Re: Objection to S78 Appeal (PINS Reference: APP/X5210/W/25/3360840) relating Planning Application 2024/3123/P, that refused the 'Erection of single-storey roof extension to provide 2 new residential (Class C3) units' at: Glebe House, 15 Fitzroy Mews, London, W1T 6DP.

Appendix 1: Objection to Refused Planning Application 2024/3123/P

Planning Application (LPA reference: 2024/3123/P) proposing the 'Erection of single-storey roof extension to provide 2 new residential (Class C3) units' at: Glebe House, 15 Fitzroy Mews, London, W1T 6DP.

Figure 6: Drawing No. e-103, with an annotation inserted to show the difference between 4-7 Fitzroy Mews and Glebe House.

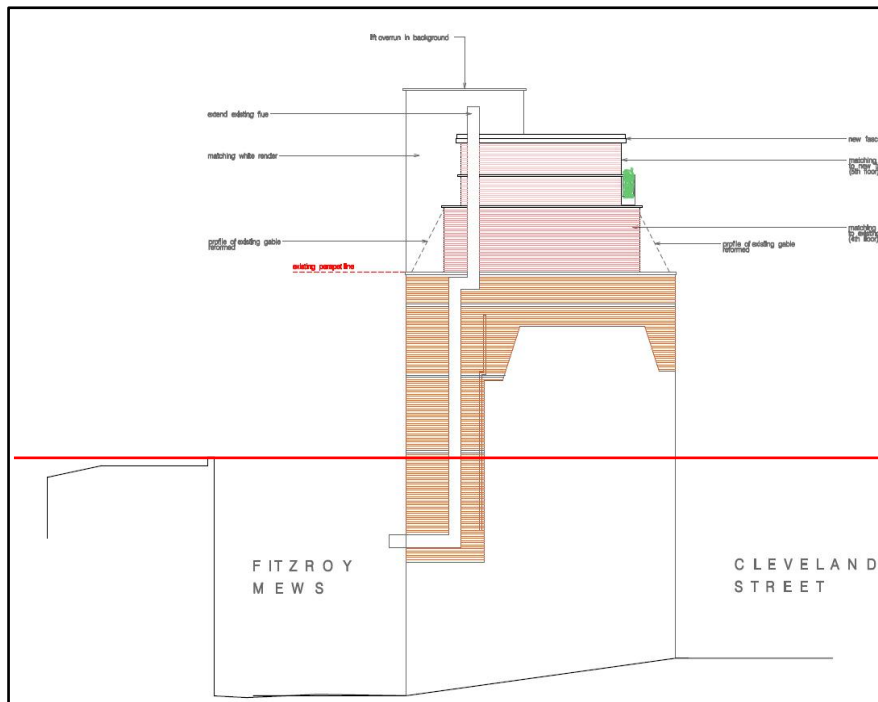
No dimensions were included on any of the plans submitted with the refused Planning Application (reference: 24/3123/P). It is therefore difficult to properly understand the scale of the development in relation to the surrounding buildings. This was further exacerbated by the exclusion of a topographic survey and/or site levels to acknowledge the difference in elevations between Fitzroy Mews to the east and Cleveland St to the west; this difference is especially apparent as per the proposed north elevation (Drawing No. e-103), see Figure 6. Notwithstanding, measurements of the submitted plans using the scales provided, indicates that there is an approximate 1.8 m difference between the two frontages, therefore the units located directly opposite Glebe House within the

Mews (4 – 7 Fitzroy Mews) sit considerably lower than the Glebe House. The mews have an overall height of 8.5 m, should the appeal be allowed, the eastern elevation of Glebe House would measure to be 22 m in height from Fitzroy Mews and dominate over 4-7 Fitzroy Mews by approximately 13.5 m as shown in Figure 6 below.

As stated previously, Planning Application 24/3123/P has failed to articulate the full scale of the proposed development and the significant negative impact it will have on the relationship between Glebe House and the neighbouring properties both along Cleveland Road and within the Mews. This is considered to be far more negatively impactful than is the case with the sensitively designed approved development at Cleveland Court which matches and respects the high-quality architectural detailing and materials of that existing building.

Figure 3: Dwg No. e-100, with two red lines inserted to compare the height of neighbouring buildings.

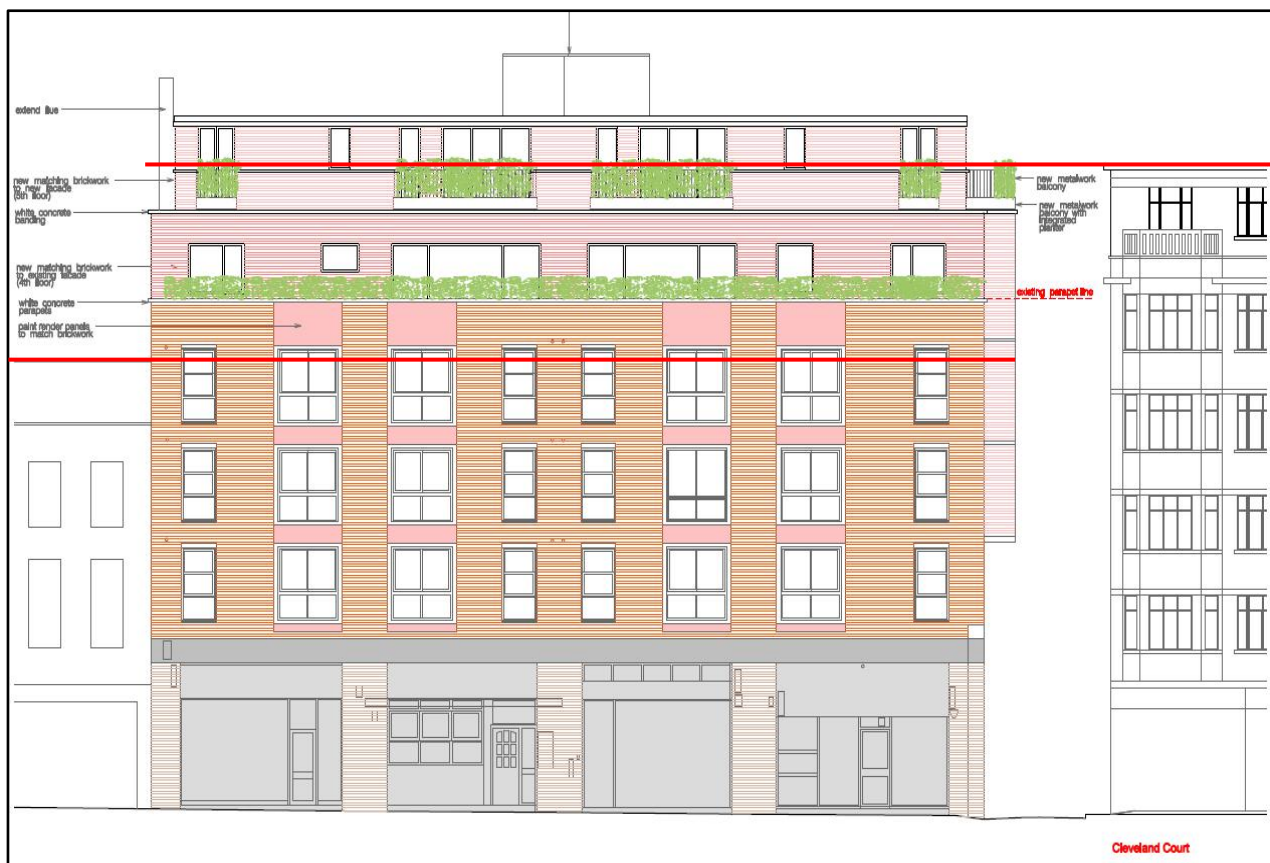
Drawing No. e-100 (Figure 3), shows the proposed front elevation of Glebe House which fronts Cleveland Street and includes the adjacent/adjoining terraces located directly north and south. Annotations have been inserted to indicate the height of these existing buildings in contrast to Glebe House after the proposed works have been completed. It is clear that the additional storey would result in an overly dominant building with no positive relationship with nearby buildings, particularly the adjoining terrace to the north (100-126 Cleveland Street).

By not providing dimensions on the submitted plans, the Applicant has made it difficult for the Local Planning Authority and members of the public with an interest in the proposal, to accurately understand the scale of the development. This is further exacerbated by the Applicants failure to acknowledge the difference in site levels between Fitzroy Mews to the east and Cleveland St to the west. No topographic survey was included in the planning application nor have site levels been included in the submitted plans.

Figure 4: Dwg No. e-103, with a red line inserted to show the difference in height between 4-7 Fitzroy Mews and Glebe House.

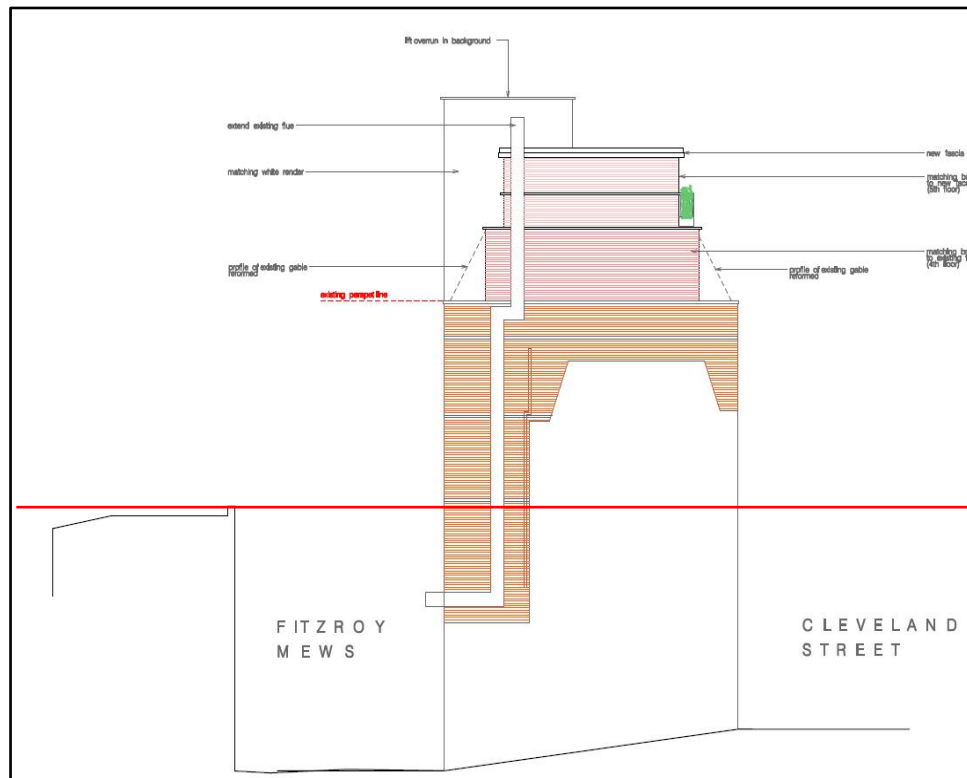
Notwithstanding, measurements of the submitted plans using the scales provided, indicates that there is an approximate 1.8 m difference between the two frontages, therefore the units located directly opposite Glebe House within the Mews (4 – 7 Fitzroy Mews) sit considerably lower than the Glebe House. The mews have an overall height of 8.5 m, should the proposal be approved, the eastern elevation of Glebe House would measure to be 22 m in height from Fitzroy Mews and dominate over 4-7 Fitzroy Mews by approximately 13.5 m as shown in Figure 4 below.

Overall, the Applicant has failed to articulate the full scale of the development and the significant negative impact this will have on the relationship between Glebe House and the neighbouring properties both along Cleveland Road and within the Mews.
